17 October 2013

Re: Sydney University Abercrombie Precinct at Darlington NSW – Proposed amendments to development works in vicinity of tree

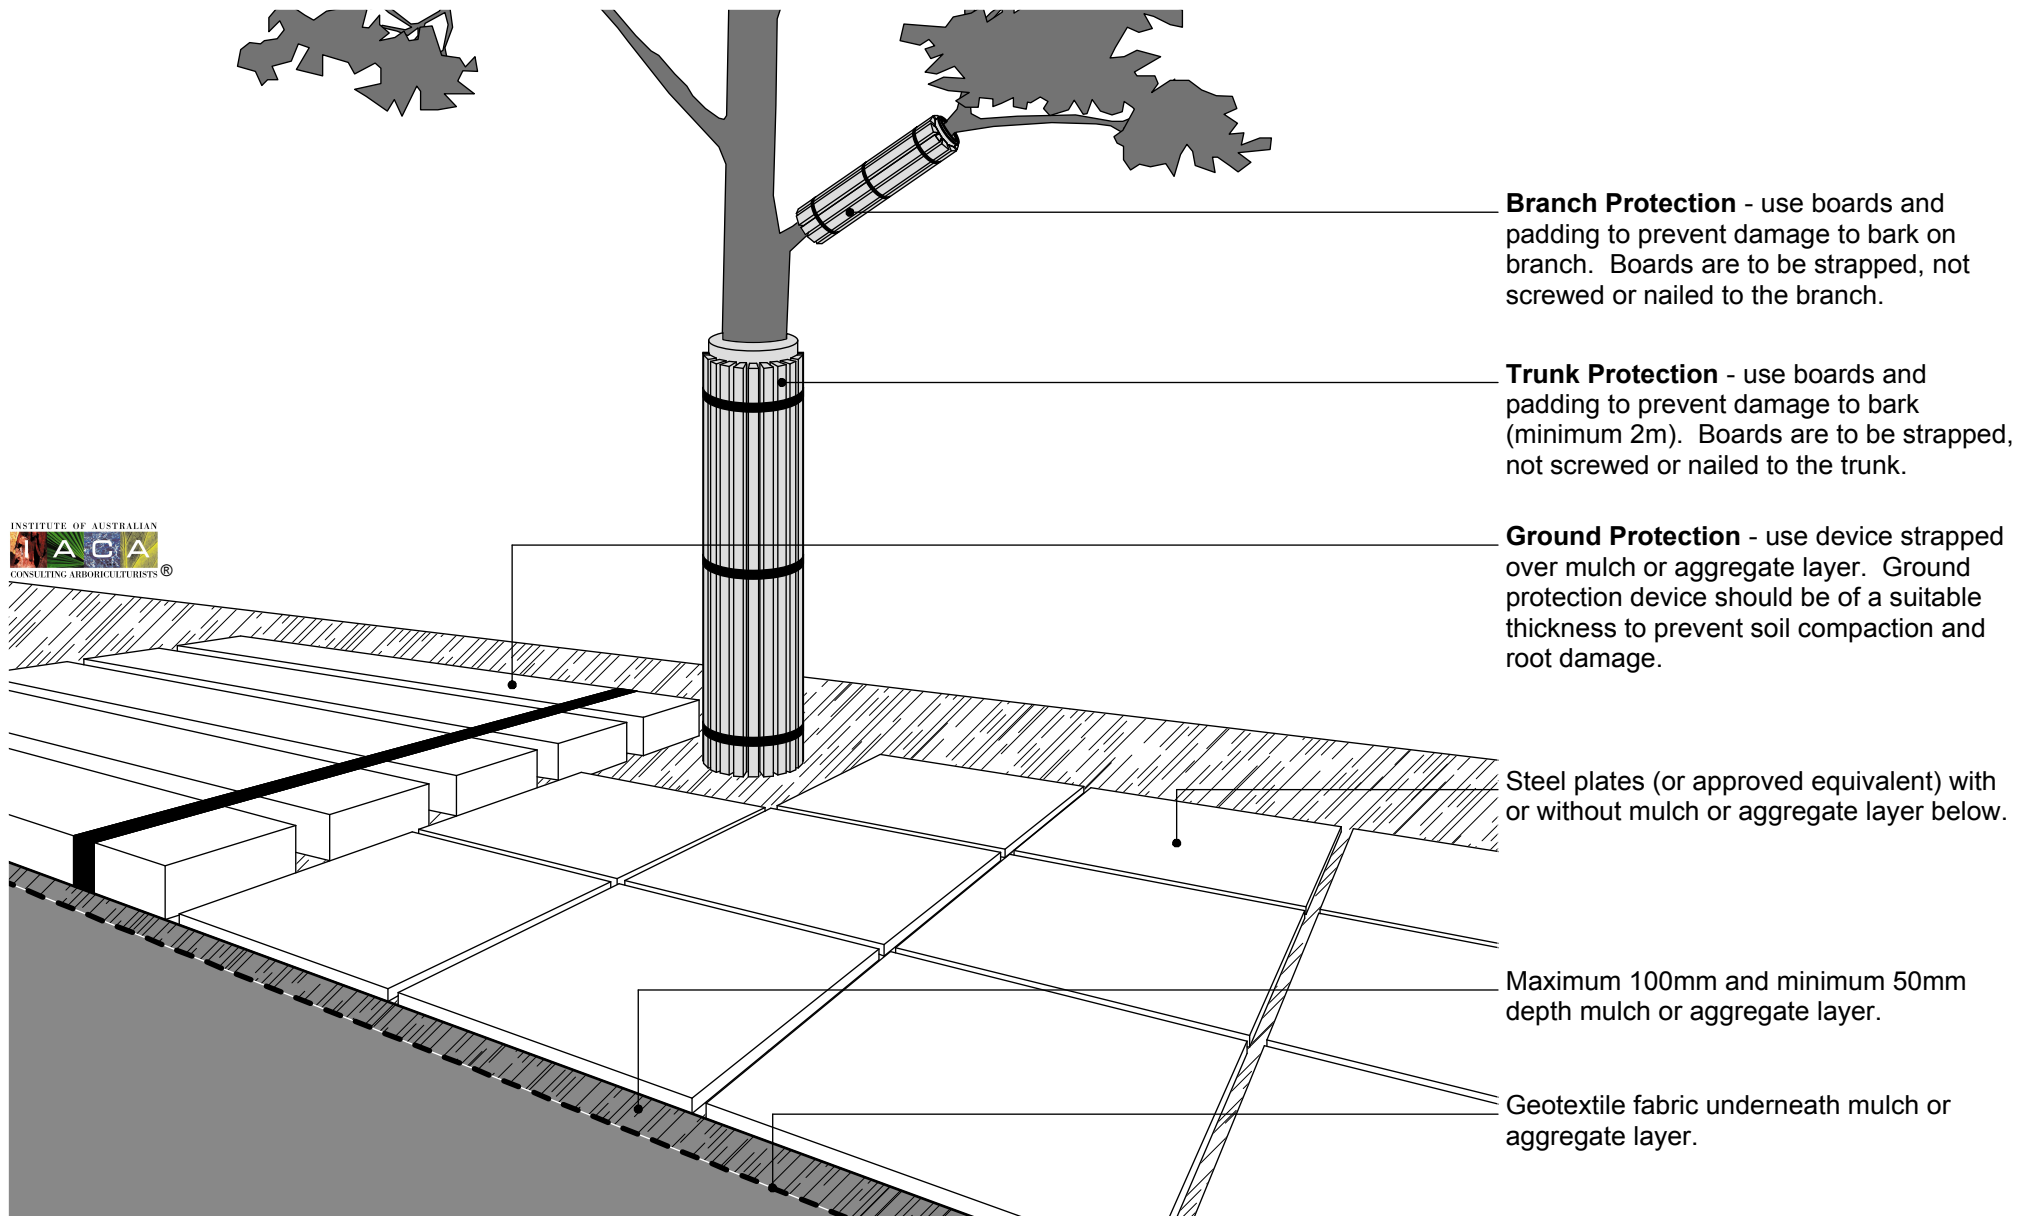
I confirm I have reviewed the proposed amendments and identified the 2 areas of proposed encroachment into the TPZ are as follows:

$27.22\text{m}^2 = 5.79\%$ of TPZ; and
 $13.91\text{m}^2 = 2.96\%$ of TPZ.

The total encroachment is less than 10% of the tree's identified TPZ – this is a minor encroachment under AS4970-2009 and is within an acceptable threshold.

As previously advised, it is recommended that those areas of the TPZ not able to be protected by tree protective fencing (due to the need for construction access) will need to be protected by ground protection as identified in Figure 4 of AS4970-2009. The ground protection measures identified in Figure 4 of AS4970-2009 are illustrated in the attached diagram.
